Project #: HTR 22-00008

DATE: PLANNING COMMISSION MEETING OF AUGUST 24, 2022

SUBJECT: REQUEST FOR TREE PROTECTION ZONE (TPZ) EXCEPTIONS AT 173 HAWTHORNE DRIVE (APN 061-161-020)

To: The Atherton Planning Commission
From: Sally D Bentz, Town Arborist
CC: Stephanie B Davis, Principal Planner
Date: 8/9/22
Re: Tree Protection Zone (TPZ) Exceptions – 173 Hawthorne Drive

Figure 1: Existing & Proposed Conditions – Partial Site Plan

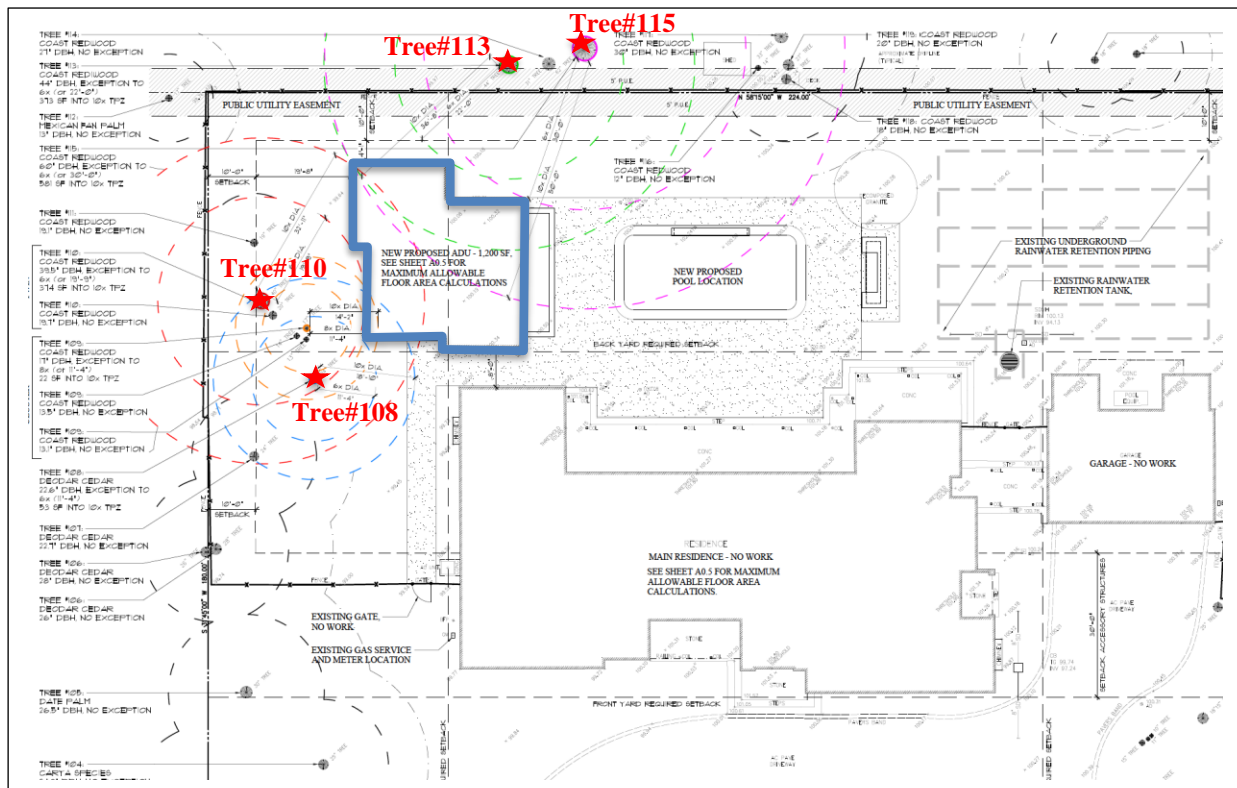
See Figure 1 below. The blue outline indicates the proposed location of the new detached ADU. Trees #108, 110, 113 and 115 are marked with a red star.

Figure 2: Proposed TPZ Encroachment – Site Plan Excerpt

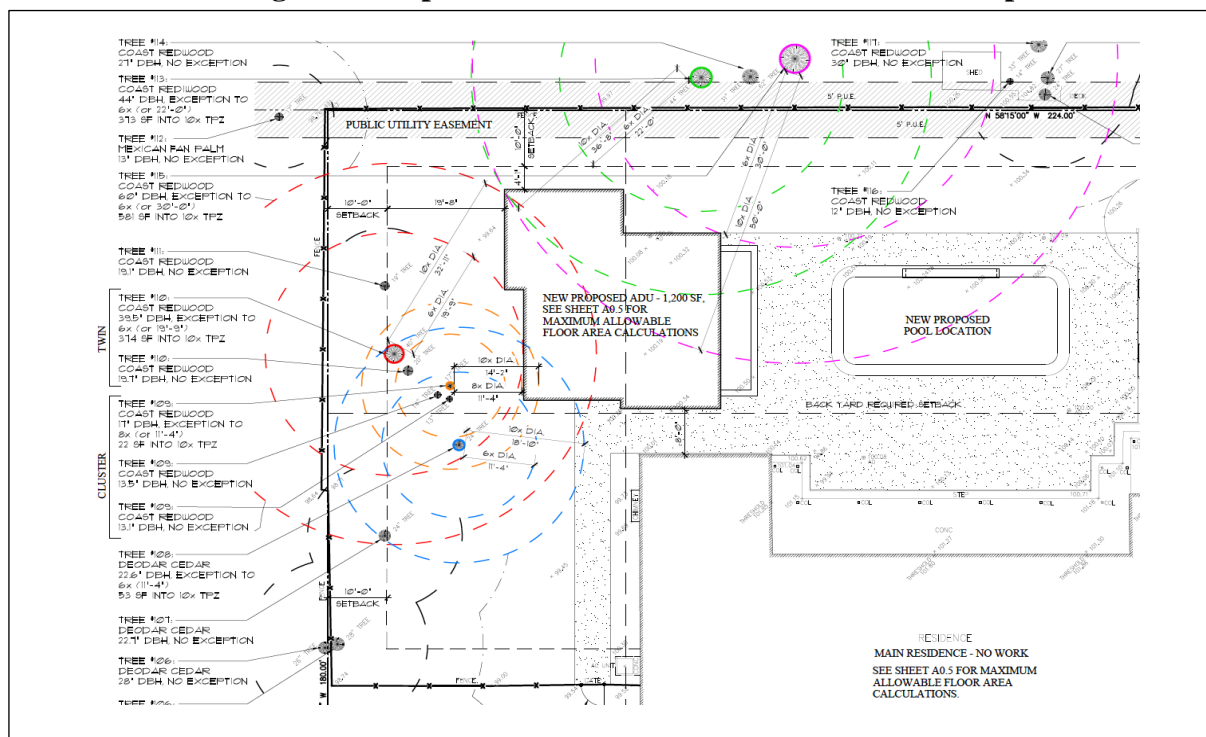
See Figure 2 below, an excerpt of Sheet A0.2 from Attachment 4. The four (4) proposed trees requesting TPZ exceptions are noted.

1 PROPOSED PIER LOCATIONS - ADU FOUNDATION PLAN
A2.1 1/4" = 1'-0"

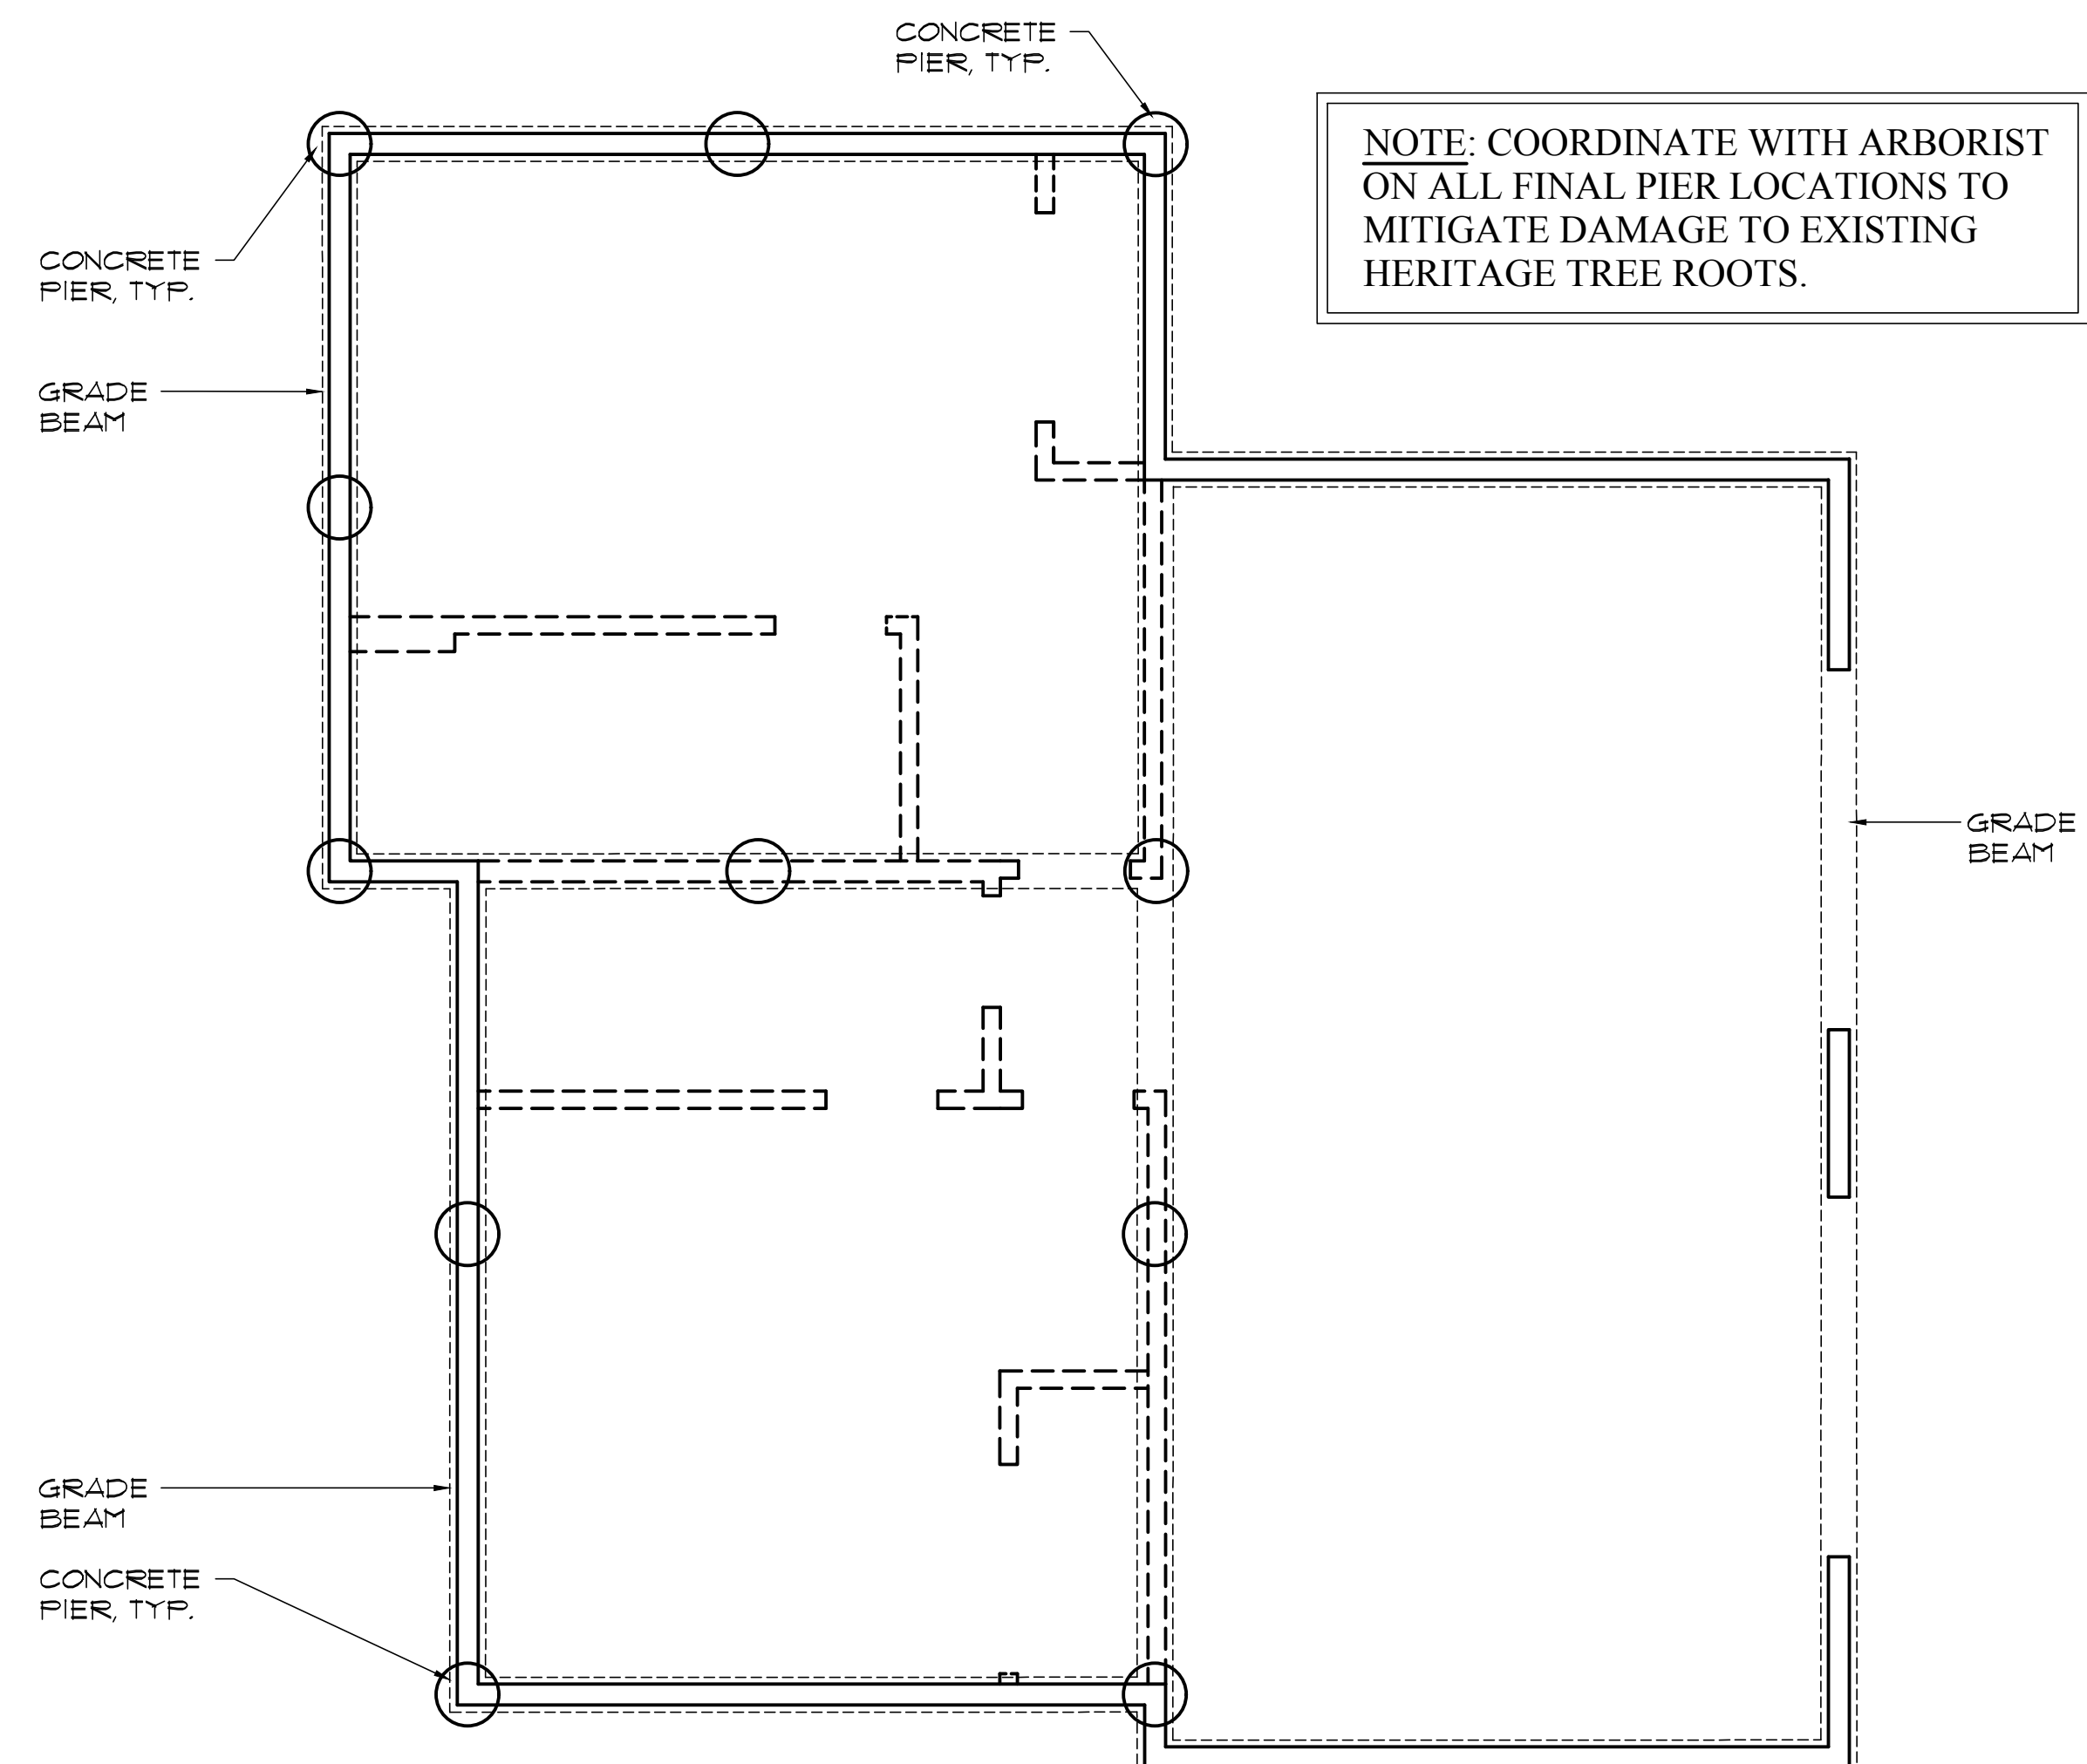
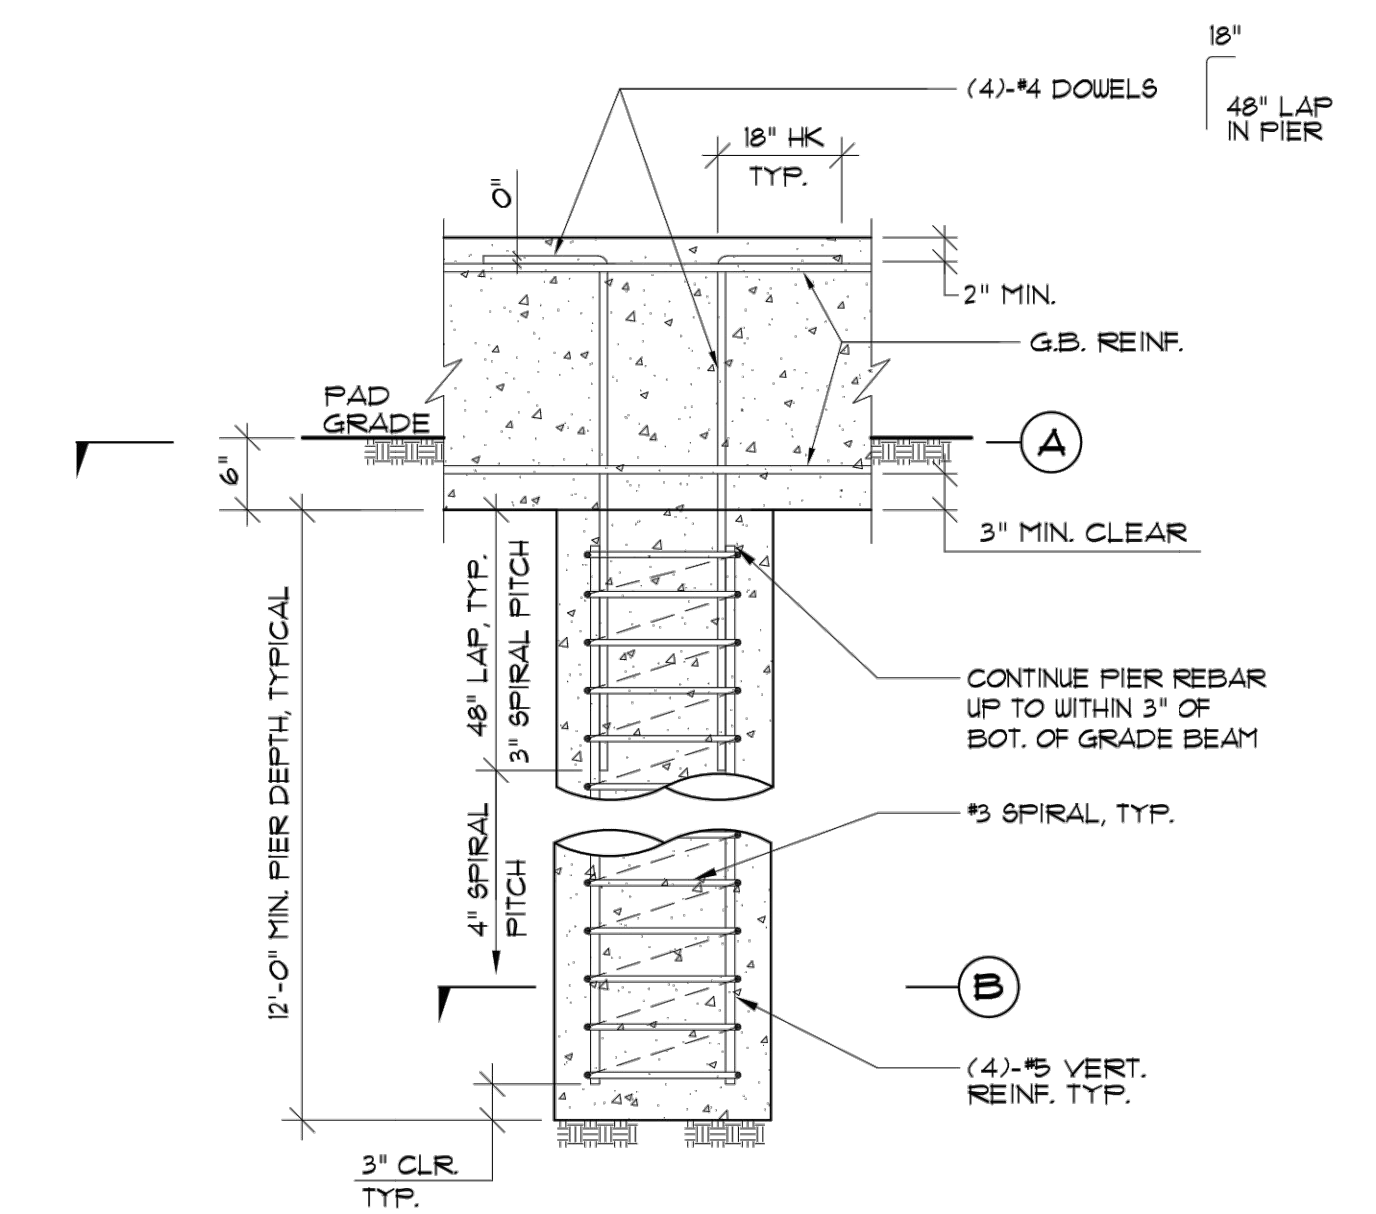
For tree #108 the impact into the 10x zone is only 53 square feet. This is a very minimal amount. However, roots were found so the pier and grade beam are necessary. A lighter grade beam and piers positioned where there are no significant roots will be required for me to recommend the 6x TPZ.

For tree #110 roots were found so the pier and grade beam are necessary. A lighter grade beam and piers positioned where there are no significant roots will be required for me to recommend the 6x TPZ. The applicant worked with the Town to come up with a less intrusive design and foundation. The site does have many heritage trees and constraints, and this is the only location for an ADU.

A certified arborist must be on site when foundation work is being done and shown on the monthly arborist report. No roots over 2” can be cut and the tree will need to be protected with metal fencing. The cut can be no further than the above exceptions.
